MINUTES

PLANNING COMMITTEE MEETING No. 233

Thursday 23 November 2023

2.1. PP-158-2023 - 24 Patullos Road, Lara

Figure 37: Extract from the S4 subdivision plan creating 19 lots and Reserve No.1 and Reserve No.2. Note that Reserve No.2 at the east end (right) is mis-labelled to be RESERVE No.1. Source: Application documents.

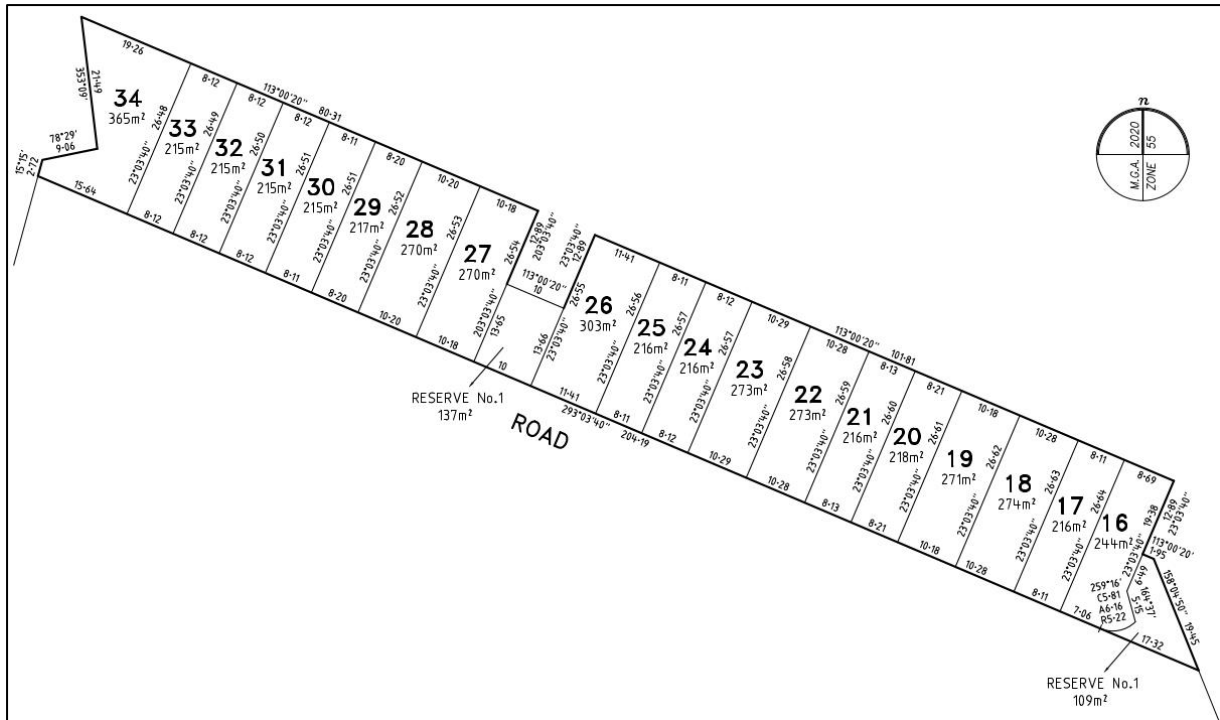
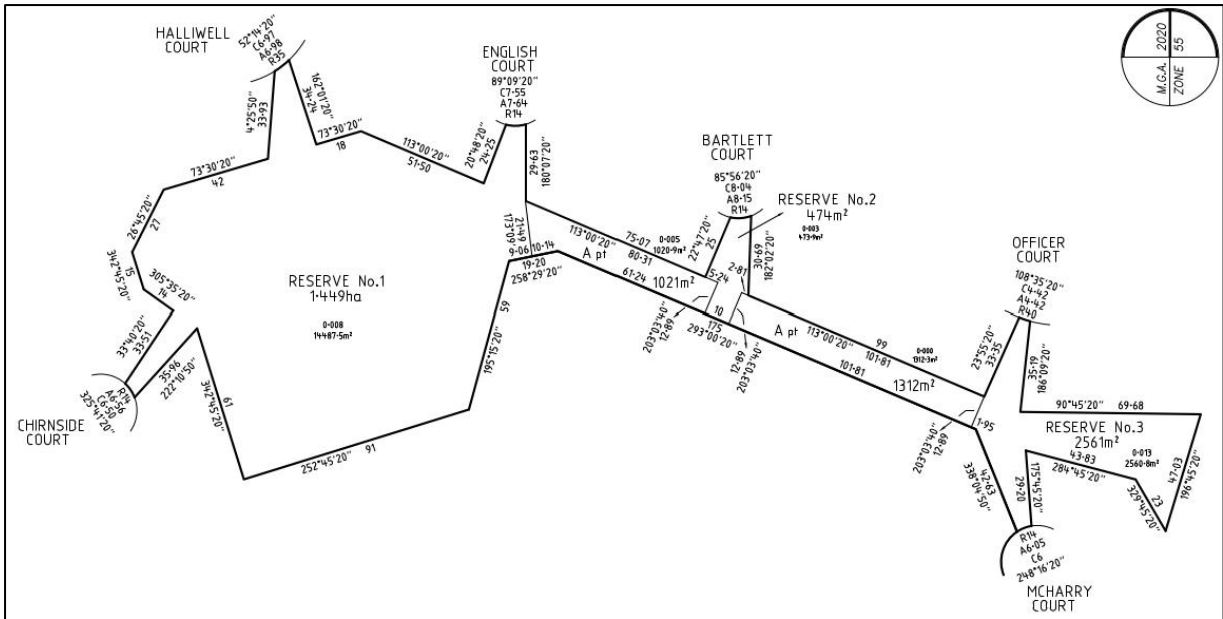
It is notable that RESERVE No.1 on PS913295M created at Stage 4 (ref. Figure 37 previous) is located on the same land as RESERVE No.2 on PS913229B created at Stage 1 (ref. Figure 31 previous), and the mis-labelled eastern RESERVE No.1 on PS913295M is located on the same land as RESERVE No.3 on PS913229B created at Stage 1.

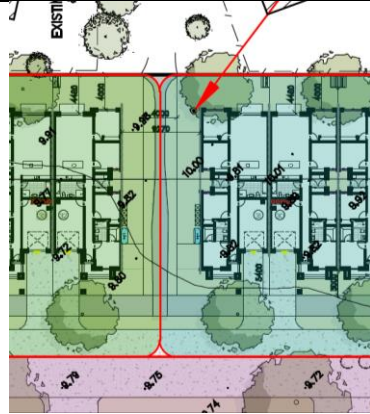
The proposed 4m width pedestrian link reserve connecting to Bartlett Court (as shown below) will need to be a minimum 10m in width. This is our minimum acceptable width for a pedestrian link reserve to ensure adequate passive surveillance and sense of safety.

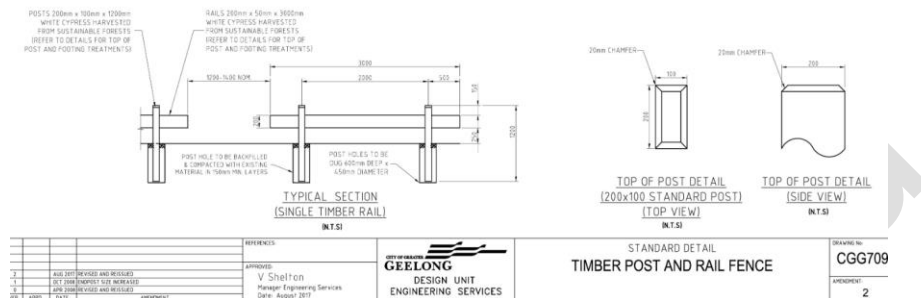
The pedestrian link reserve connecting to Bartlett Court is too narrow, as previously stated our minimum required width for a pedestrian link is 10m to ensure adequate passive surveillance and public safety.

Please update the Landscape Master Plan to show the super lot a different colour to the 'Townhouse lot garden area to future detail design' for improved legibility as they currently read as the same thing.

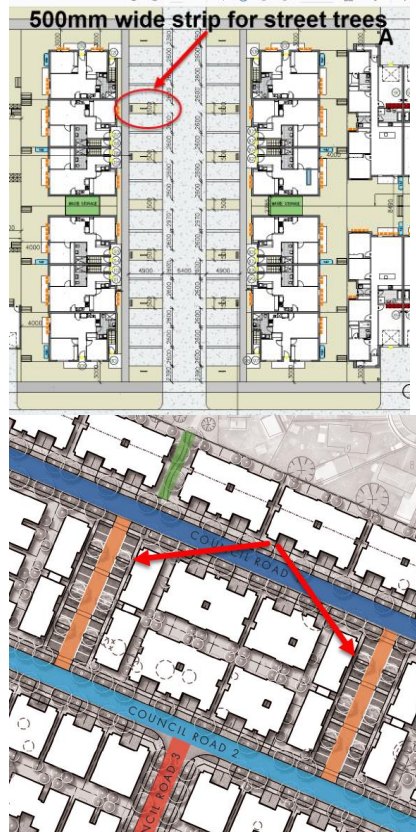
The following species are very hard to establish in the Corio area,

Species substitutions could be taken from the following list,

Figure 41: Garden Area Analysis plan submitted as part of the application, understood to show the area to be set aside for garden shaded pink. Source: Application documents.

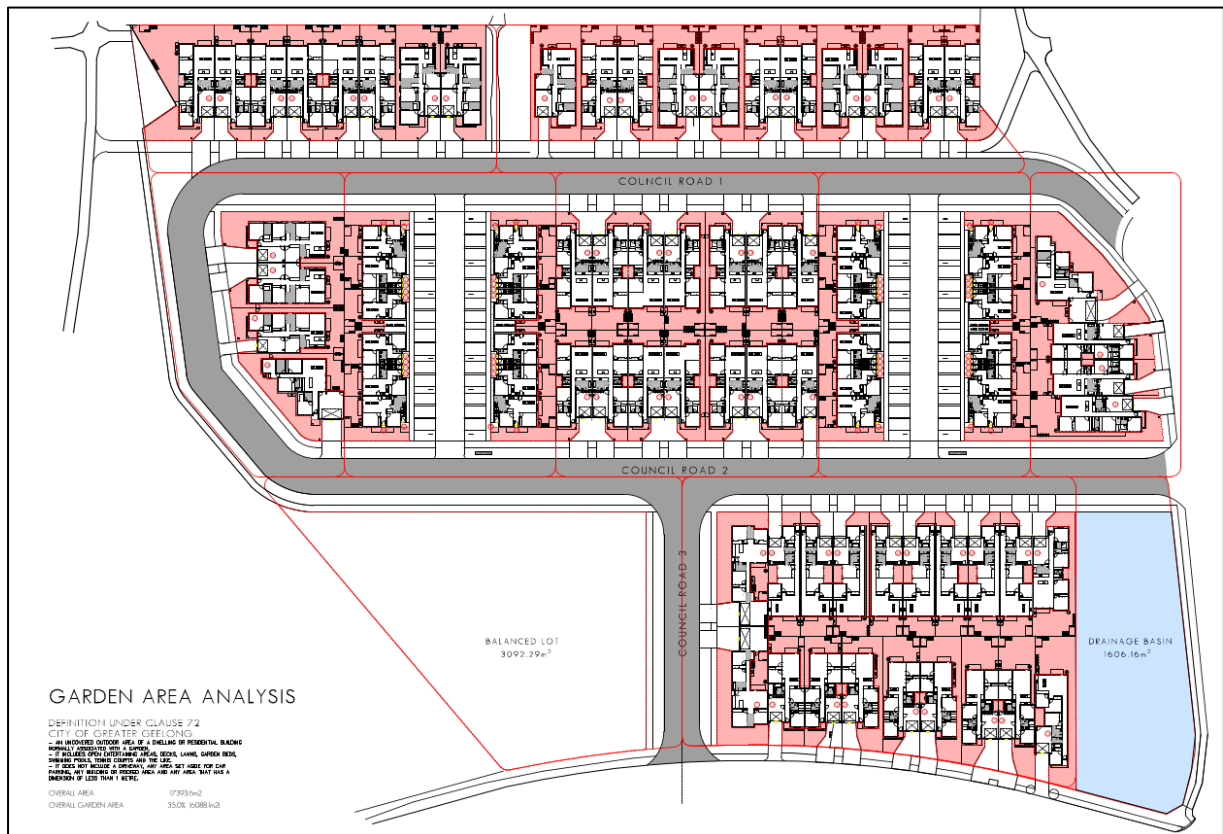
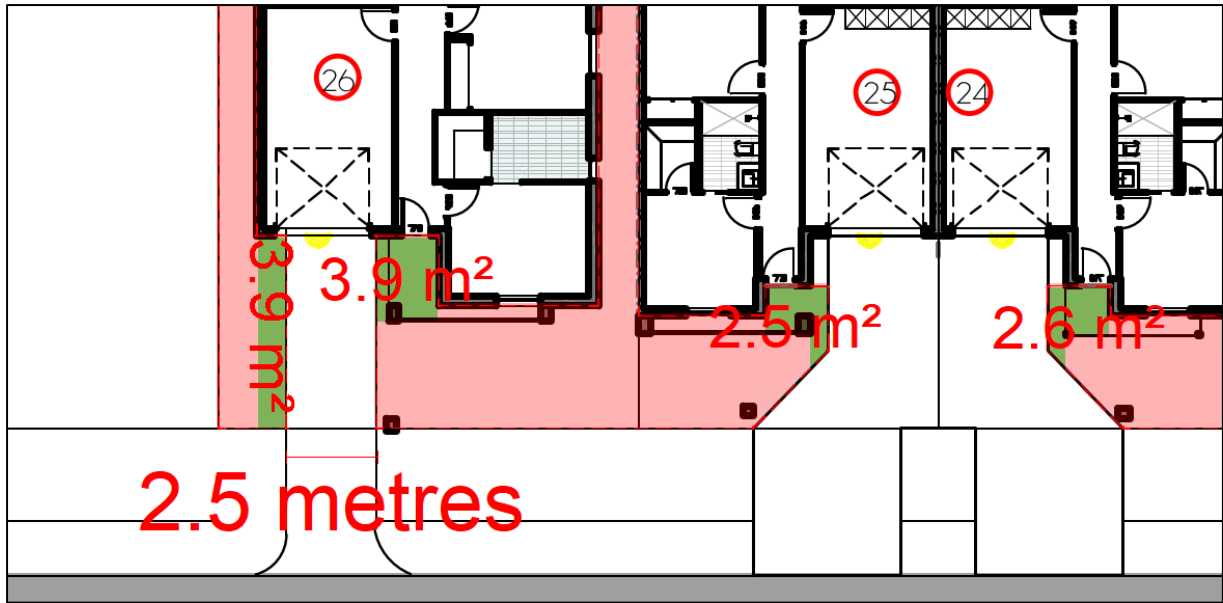
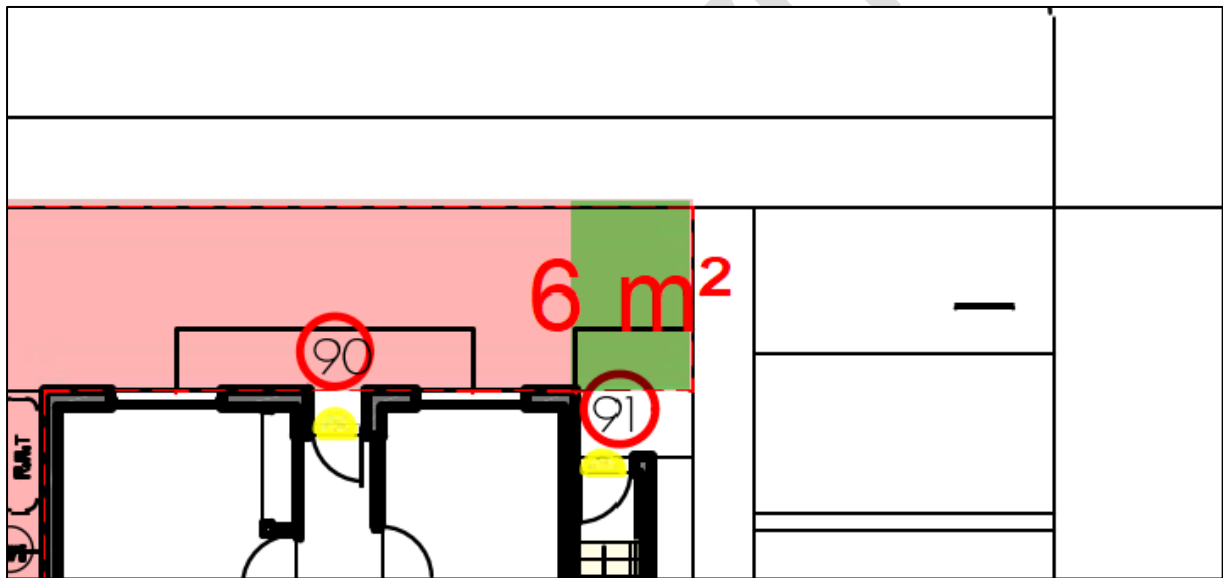
Further, the garden area analysis plan submitted includes a significant number of areas that do not conform with the garden area requirement as defined at Clause 73.01 (General Terms). For example, areas of less than 1m, areas under porches, and undersized vehicle accessways (Figure 42); areas of common property nominated on the subdivision plan (Figure 43); and corner splays required by Standard C20 of Clause 56 (Residential Subdivision) have all been incorrectly set aside as garden area.

Figure 42 (above): Extract from the Garden Area Analysis plan annotated to show examples (green) that have been set aside as garden area that do not comply with the garden area definition of the Scheme. Source: Application documents, annotated by the Author.

Figure 43: Extract from the Garden Area Analysis plan annotated to show an example (green) of an area incorrectly set aside as garden area but on land nominated to be part of the common property, and not part of a future lot. Source: Application documents, annotated by the Author.

Figure 47: Plan showing the extent of the proposed development located within the outer safety area (shaded yellow) of the Viva Geelong Refinery Major Hazard Facility. Source: Application documents, annotated by the Author using MHU WorkSafe map provided.

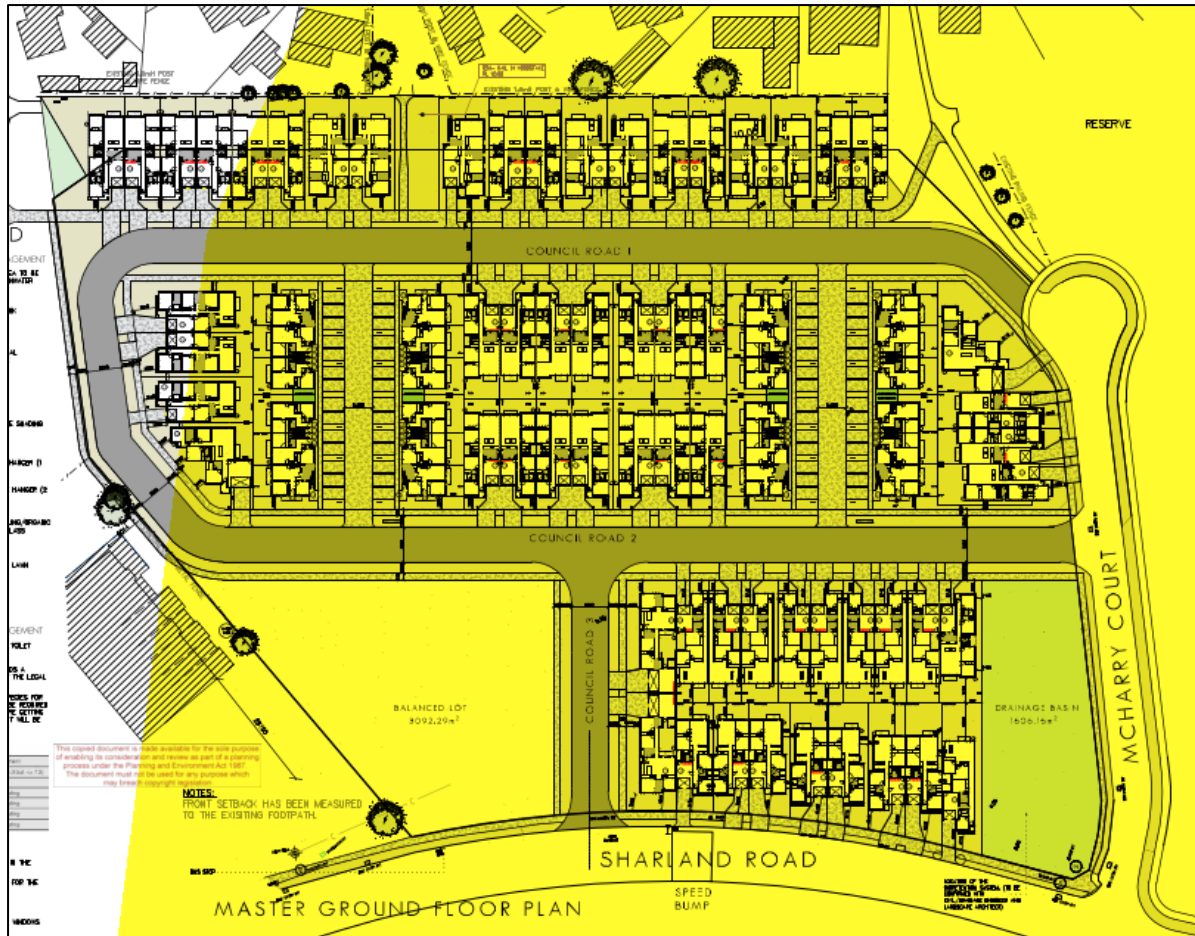
The extent of the proposed development that is located within the outer safety area is shown at Figure 43 below. This area includes all but 4 of the 104 proposed dwelling lots.
